Request for Approval to Contract for the  
Design and Fabrication of a Dual Format  
Data Block Reader with Fairchild Space  
& Defense Systems Division at a Cost of  
 from FY-1972 R&D Funds.

Subject: Submittal of Revision to Dual Format Data Block Reader

DUAL FORMAT DATA BLOCK READER  
Proposal No. ED-CX-14 Rev. 2  
6/11/71

FIGURE 1 - 70MM FORMAT  
EMULSION UP

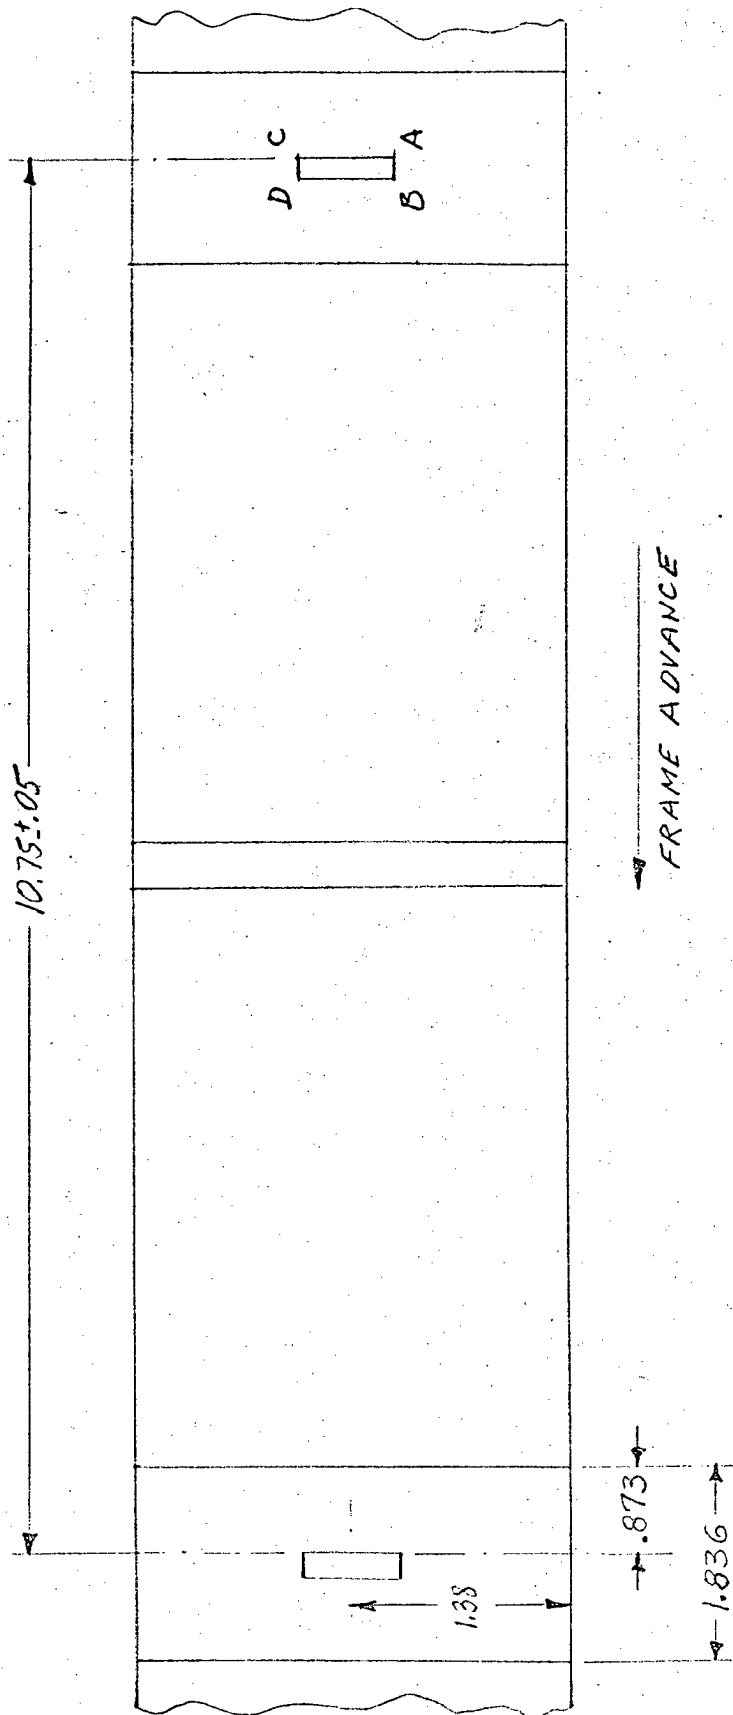
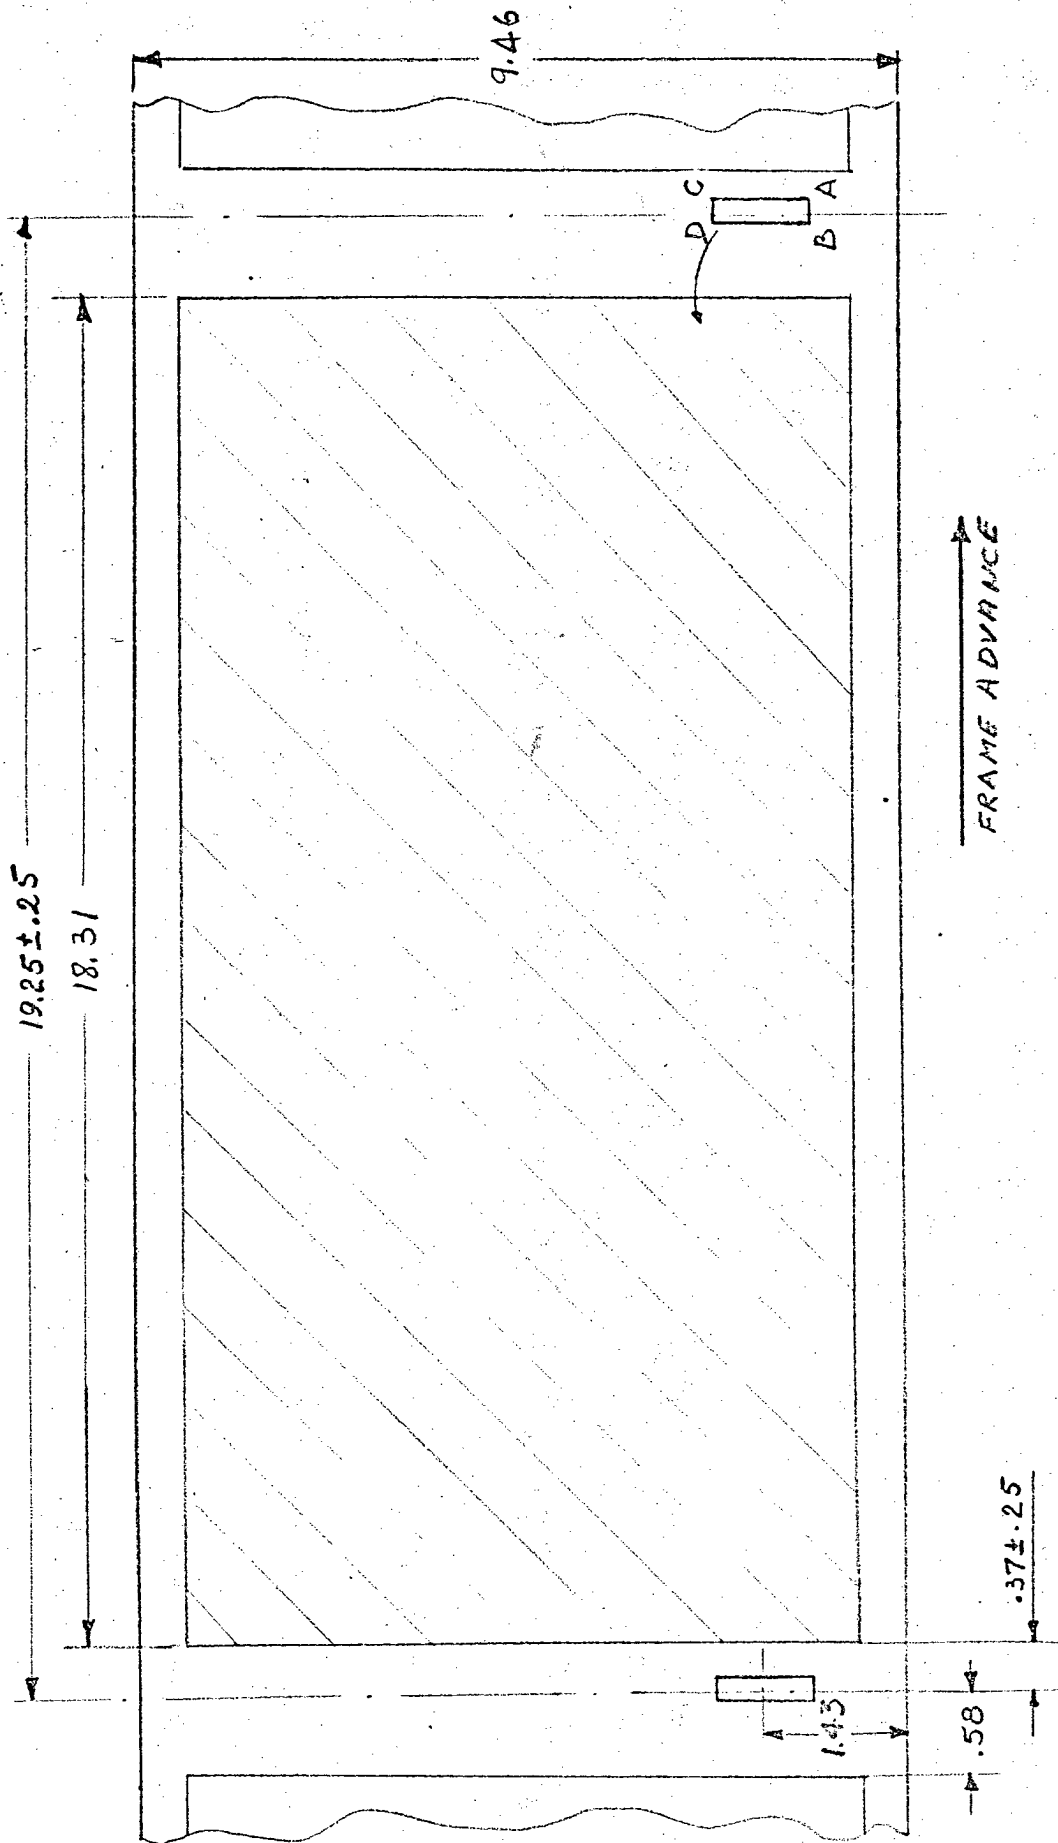
Each of the two formats will comprise of either 5 or 6 files of 32 dots each, in place of the original 5 files. Dot size, spacing and density does not change, but the index dot distribution within the data block is different than the one shown in Figure 3 of proposal ED-CX-14 dated 10/7/69, Data Block location and film size (Figures 1 & 2 of proposal ED-CX-14) did not change.
